Product / Process Change Notification (PCN)

PCN #: PCN_UtSTST_20240512

Affected Series: WE-STST;
 749302010, 749302011

1. Recommended land pattern

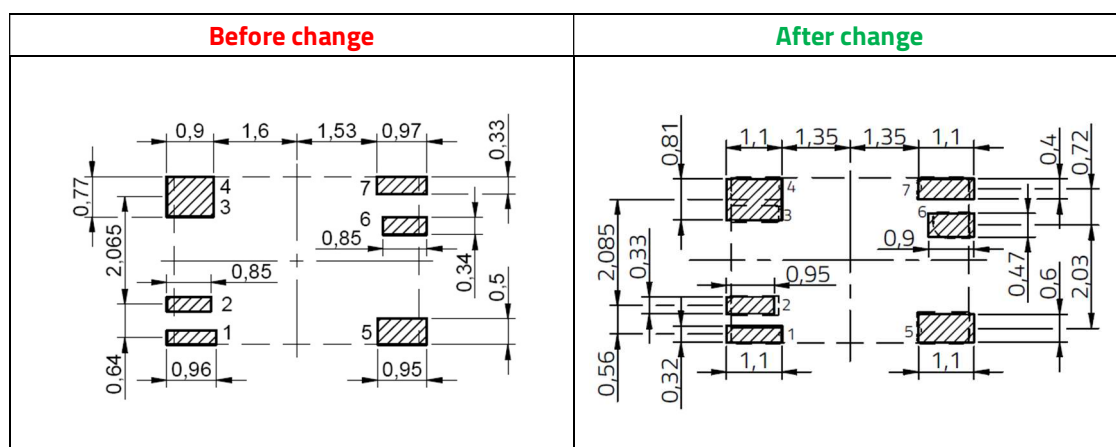
Because of a database mismatch, Würth Elektronik will change the recommended land pattern.

This is a datasheet correction only. There will be no change in form, fit, function, quality or reliability of the product.
